Thank you for your comments regarding the proposed development at 56 High Street, Baldock.

We have reviewed the feasibility of retaining 1T (*Taxus baccata* [yew]), now protected by TPO/00227 (2026), within the context of the current scheme. While its retention has been fully explored during the design process, our assessment concludes that this is not realistically achievable without resulting in significant arboricultural harm and materially constraining the viability of the proposed development.

Based on the current proposal, in a scenario where 1T is retained.

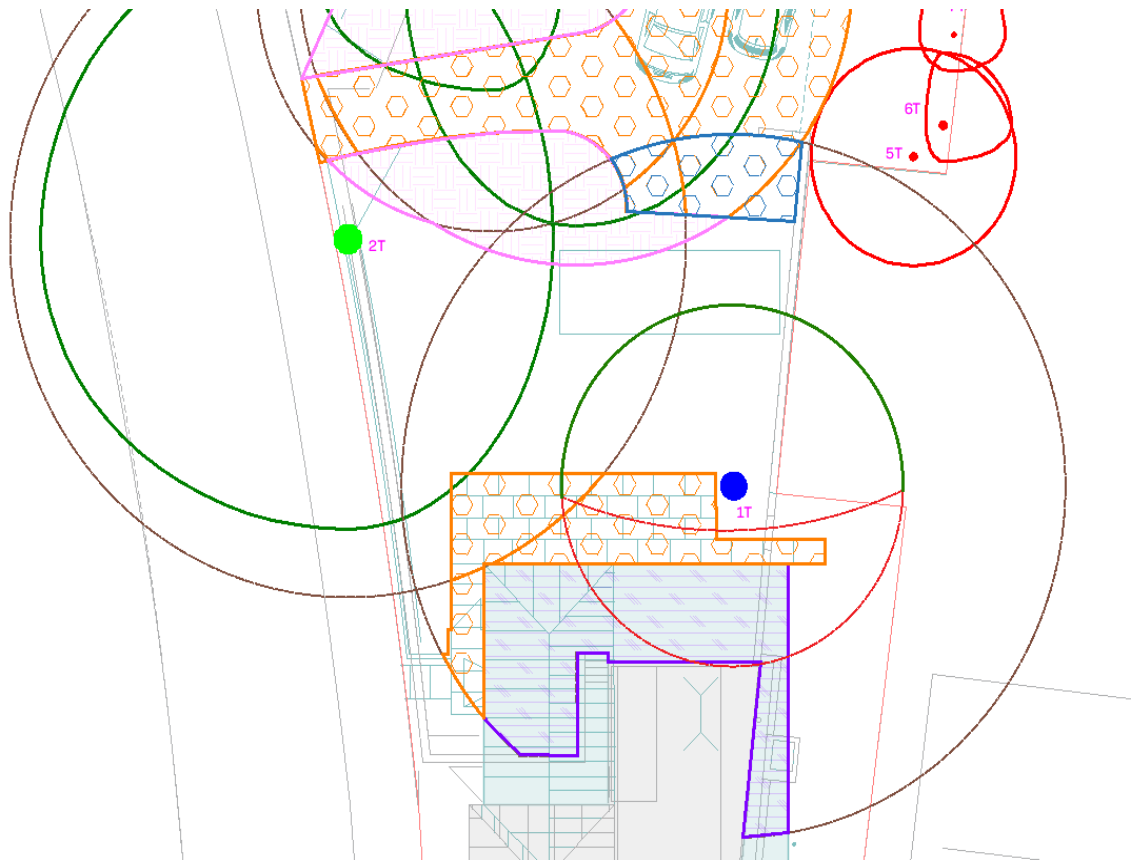
In contrast, 1T presents a unique and overriding constraint within the site layout. To facilitate its retention, a substantial unilateral crown reduction of approximately 4 metres on the southern aspect would be required to provide acceptable clearance from the proposed extension. In arboricultural terms, this degree of asymmetric pruning would be excessive and would not represent good practice under the principles of BS3998:2010. The resulting crown form would be heavily imbalanced and visually poor, while also increasing the likelihood of physiological stress, reduced vitality, and future management pressures.

The impacts upon the rooting environment are similarly significant. The footprint of the proposed extension would result in an approximate 13% incursion into the calculated RPA (circa 35 m²), while the total hard surfacing, including the driveway within the northern periphery of the RPA and the areas surrounding the dwelling, are 13.2% (circa 36 m²), increasing the cumulative RPA incursion to approximately over 26%. As illustrated in the accompanying image, the blue hatching denotes the proposed driveway incursion; the required southern crown reduction is indicated in red; the extension is shown in purple; and the additional hard surfacing around the dwelling is marked with orange hatching.

Whilst BS5837:2012 does not define universal or prescriptive thresholds for all categories of RPA incursion, as acceptability is inherently site- and impact-specific, it is acknowledged that certain incursions can be successfully mitigated through specialist design and construction approaches. In this case, however, the cumulative above- and below-ground impacts associated with retaining 1T are such that its long-term retention would likely be unsustainable and would materially constrain the functionality of the proposed development.
